ATTACHMENT 1

Responses to RAI Questions Related to HBU Cask

Attachment 1 provides the consolidated responses to the NRC's RAI related to the High Burnup Cask Project at North Anna Power Station

**North Anna Power Station ISFSI
Virginia Electric and Power Company**

**Figure 6.5-1:
Radial Locations of the Thermocouple Lances in the TN-32B HBU Cask**

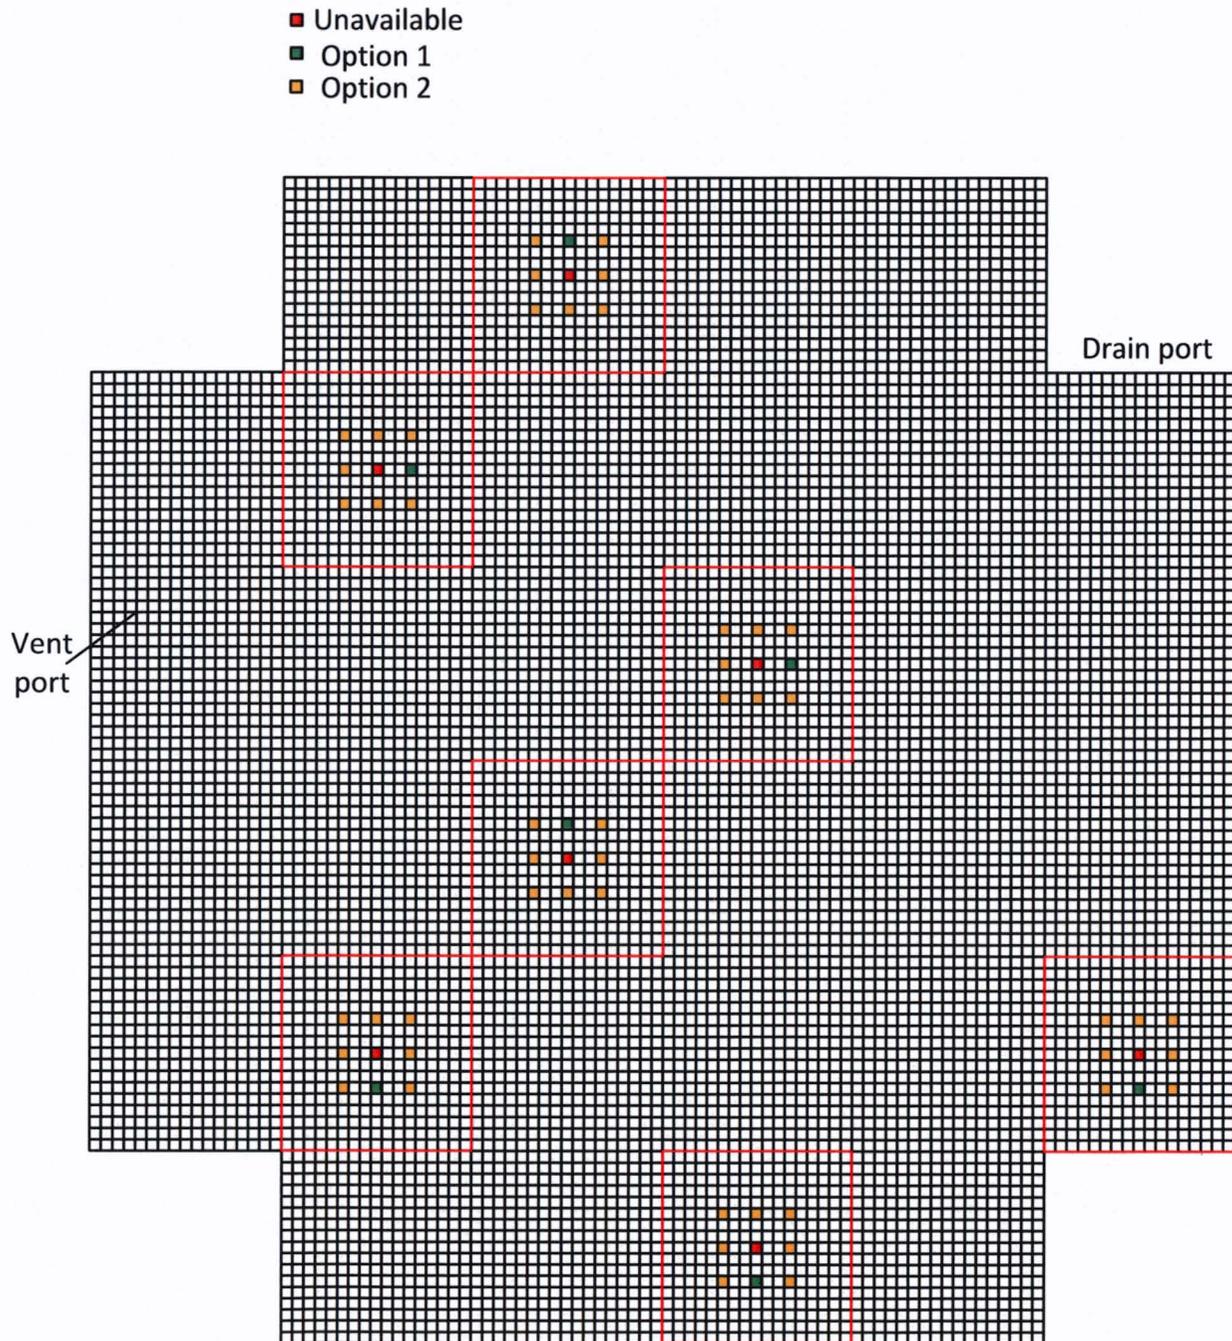
5. Clarify if the installed thermocouples will adequately capture the maximum fuel cladding temperature.

Page 8 of E-42038 states that a number of thermocouple lances will be installed in specific assemblies. However, the licensee does not provide any details on the number of thermocouples per lance location.

For the seven radial locations, there are two in the center of the cask, two in the middle, and three on the periphery of the cask (see Figure 6.5-1). For each assembly with a thermocouple lance, the specific guide tube to insert the lance into was selected to provide data of the best value from a research perspective, and was chosen considering the burnup distribution within the assembly and the predicted rod location of the peak temperature. For ease of design and installation, guide tubes were selected from one of the eight inner guide tubes. The seven radial locations are shown in the figure below as "Option 1" (green locations).
